Re: Second Technical Submission Review: Parkland Village 2, Phase 1 – Site Plan and Plat
Application Number: DA-2289-01
Case Numbers: 2022-4054-00; 2022-3092-00

Second Technical Submission Review

NEIGHBORHOOD 1 - SMALL LOT EXHIBIT

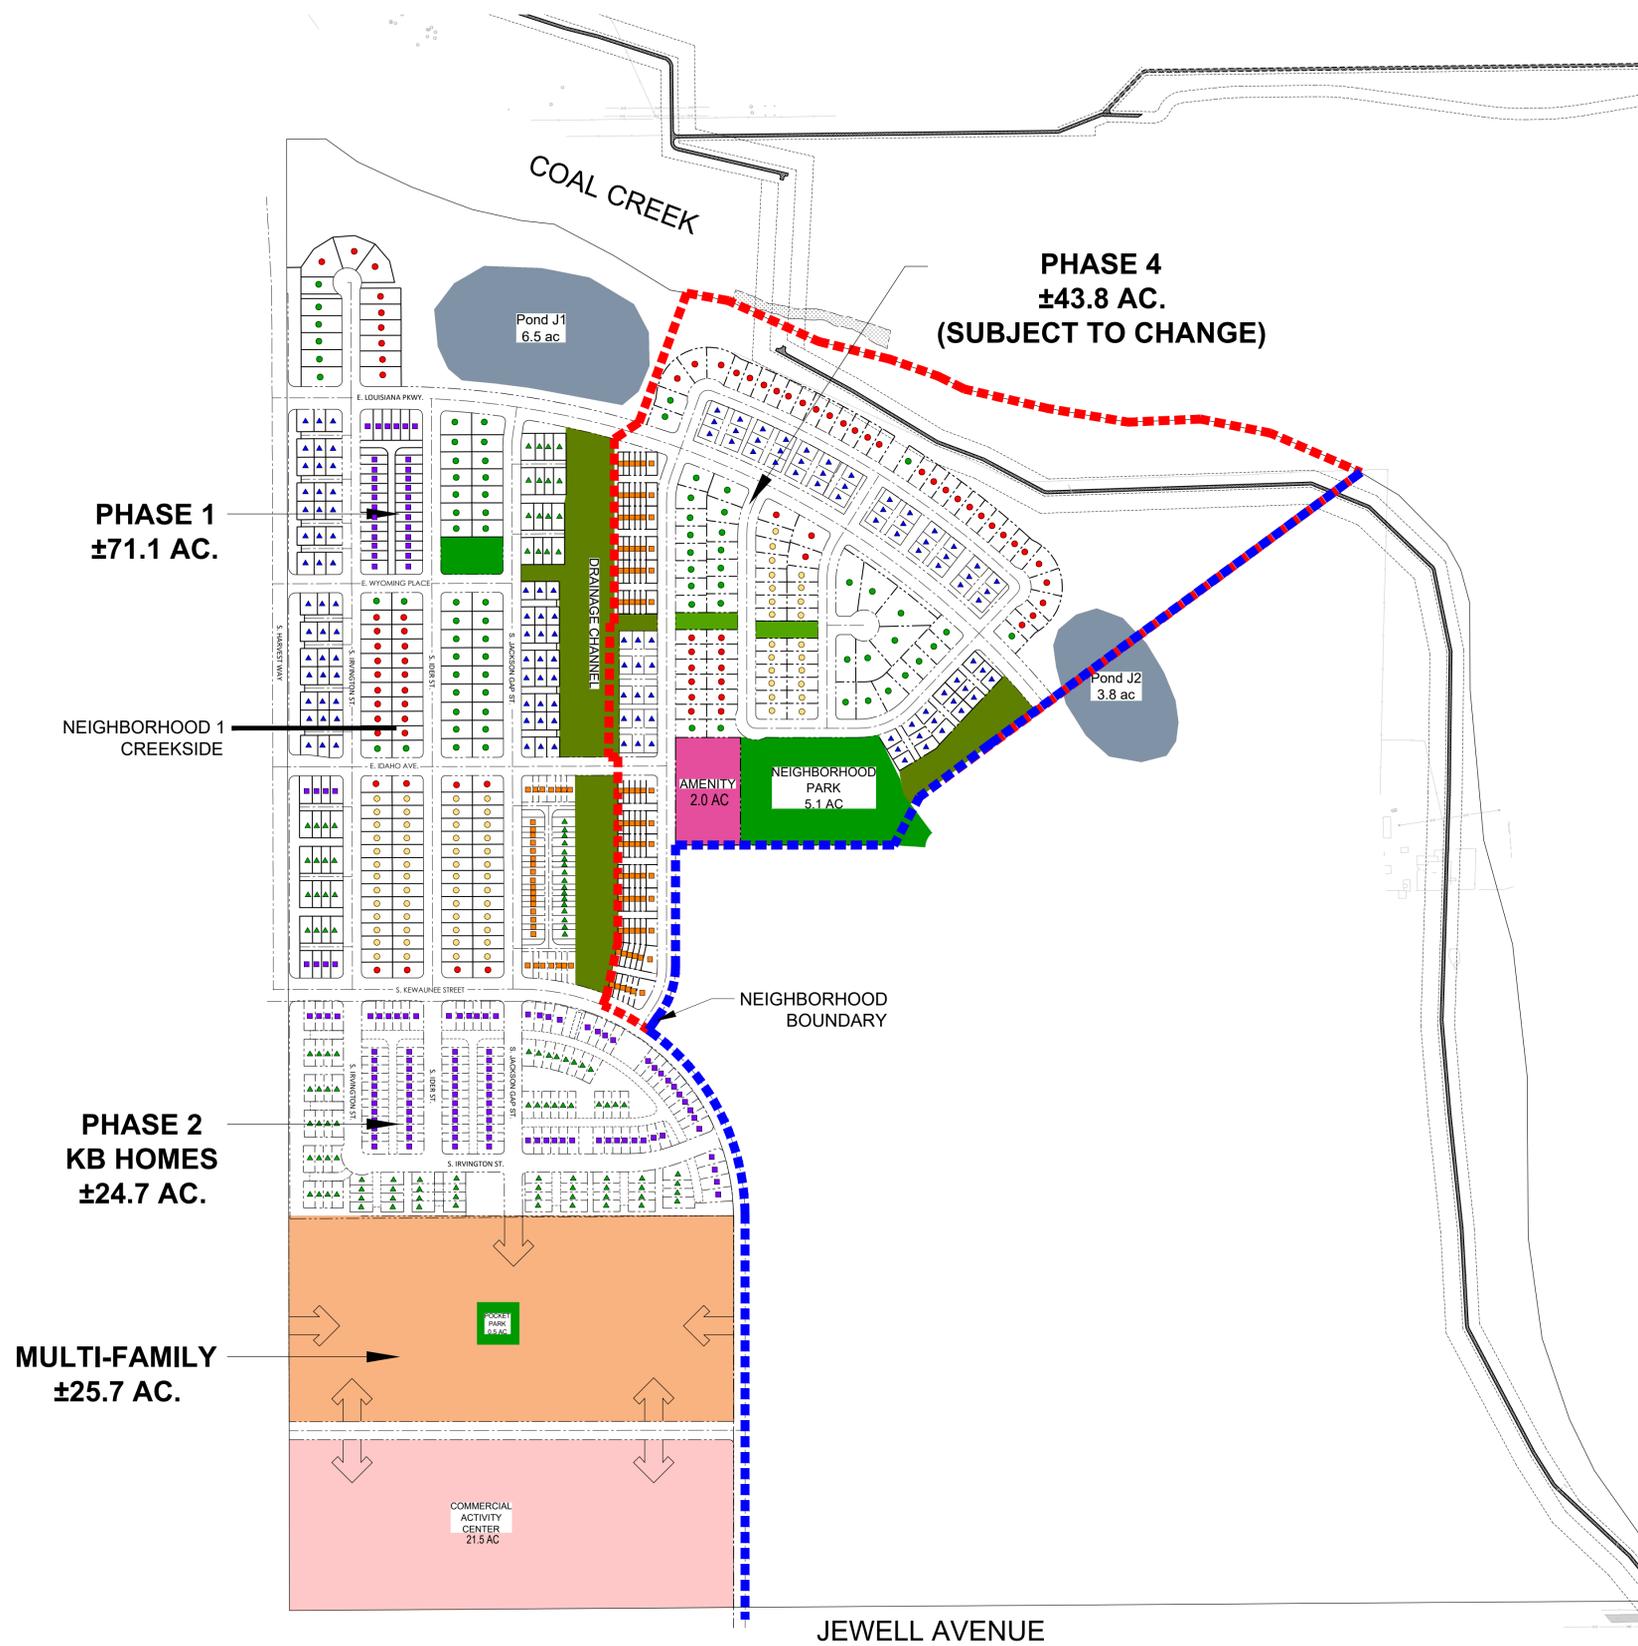
- 1D. Please provide an overall Village 2 lot tracker, including small lot and unit type counts per the Master Plan adjustment in Tab 1. This does not have to be in the Site Plan sheets but can be an exhibit. The overall lot tracker should include all unit types in the overall neighborhood, as defined in the Master Plan. Although all filings have not yet been submitted for review, the tracker table should be a running count of unit diversity. That allows the neighborhood to be evaluated for conformance to the unit mix and a maximum 65% small lot per neighborhood as indicated in the Master Plan, rather than on a filing-by-filing basis.

- The Master Plan adjustments for small lots in Tab 1 require: 1) Maximum continuous frontage of any housing type along an arterial shall be 1,000 feet; and 2) Groupings of housing types shall be dispersed throughout the neighborhood. No more than 2 contiguous blocks or 100 lots, whichever is greater, of the same housing type may be grouped. Contiguous is defined as side by side. The Master Plan also requires that each unit type be at least 10% of the overall neighborhood unit mix.
